Application for an Encroachment on City Dedicated Right-Of-Way

Location of Proposed Encroachment: Forbes Avenue and Boundary Street

**Re: ROW Encroachment Letter of Request
CMU – Richard King Mellon Hall of Sciences
4400 Forbes Ave, Pittsburgh, PA 15213
Langan Project No.: 250169701**

Drawing Title
**BOUNDARY STREET
ENCROACHMENT
EXHIBIT**

4612 Forbes Encroachment Markup

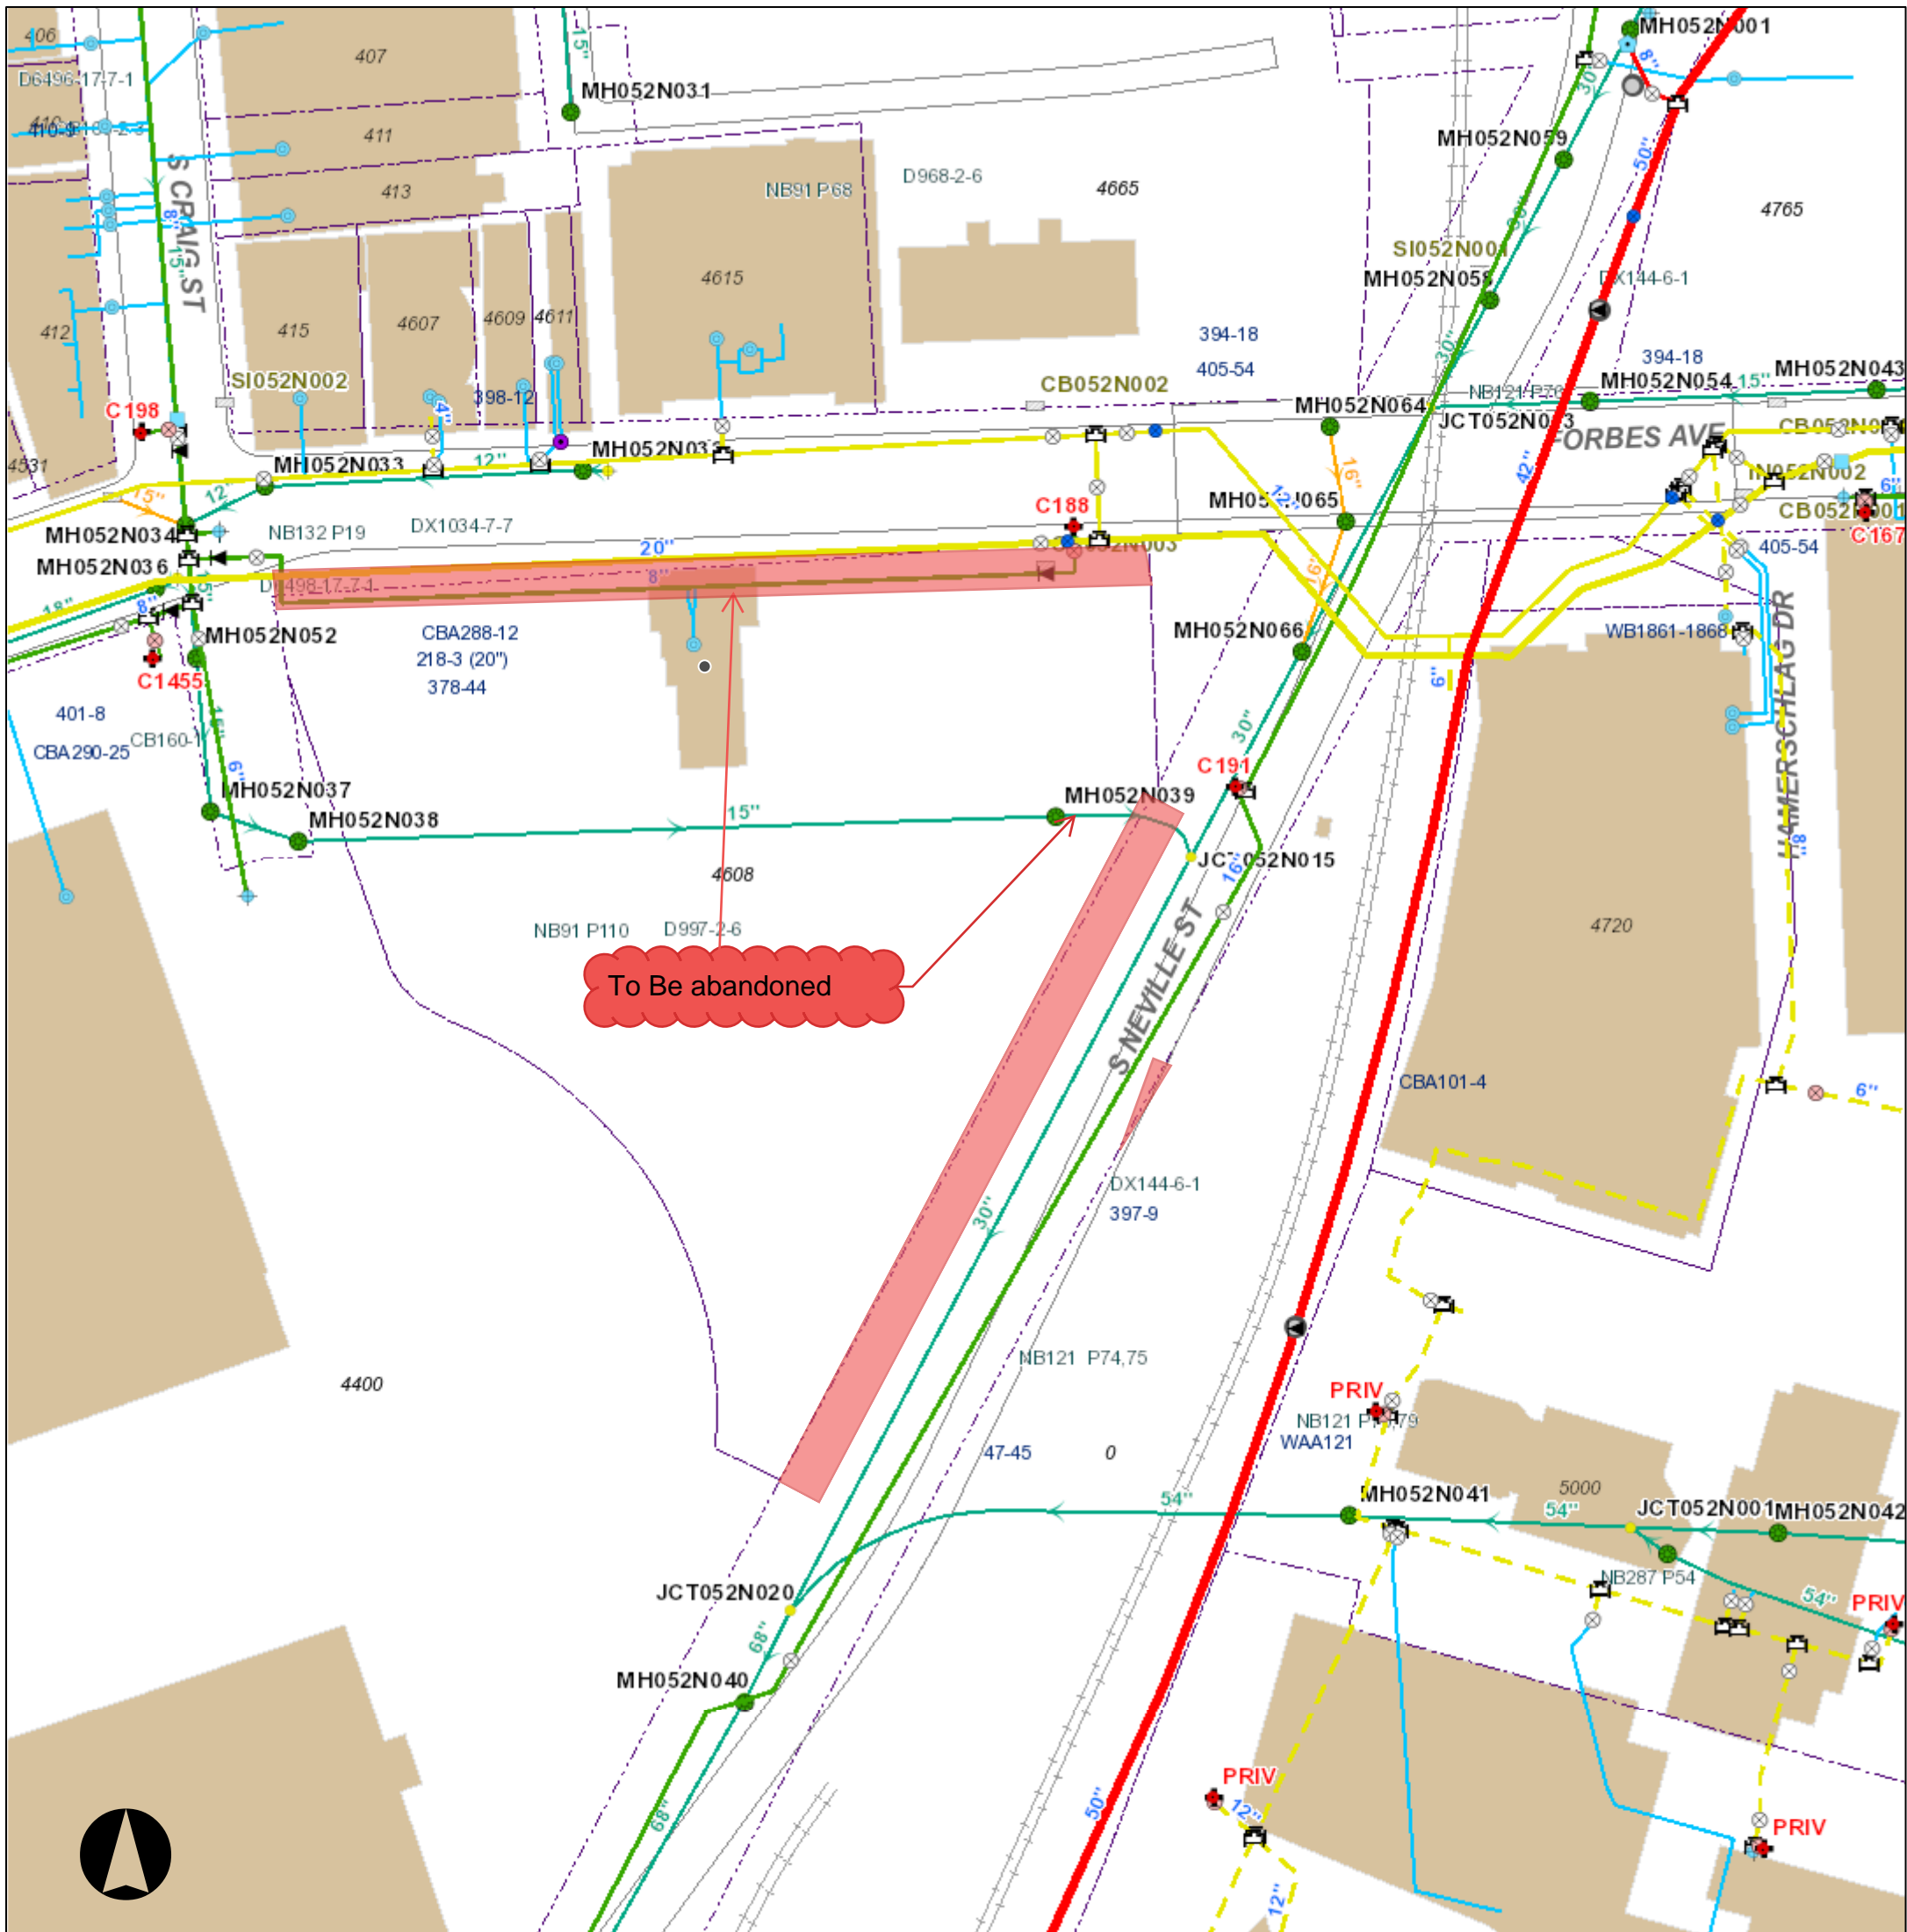
The following is in response to the attached 5/23/2024 request regarding the encroachment at 4644 Forbes Ave in the 4th Ward of the City of Pittsburgh.

1. The Water Mapping (attached) indicates that there is an 8" water main within the area of the proposed encroachment. As outlined in the Development Agreement between Developer and PWSA, the water main will be abandoned.
2. The Sewer Mapping (attached) indicates that there is a 15" combination sewer within the area of the proposed encroachment. As outlined in the Development Agreement between Developer and PWSA, the sewer main will be abandoned. Please note, PWSA does not maintain records of sewer service laterals and the property owner is responsible for maintenance. We cannot confirm if the private service lateral will be affected.

PWSA has no objection to the proposed encroachment under the conditions set forth above.
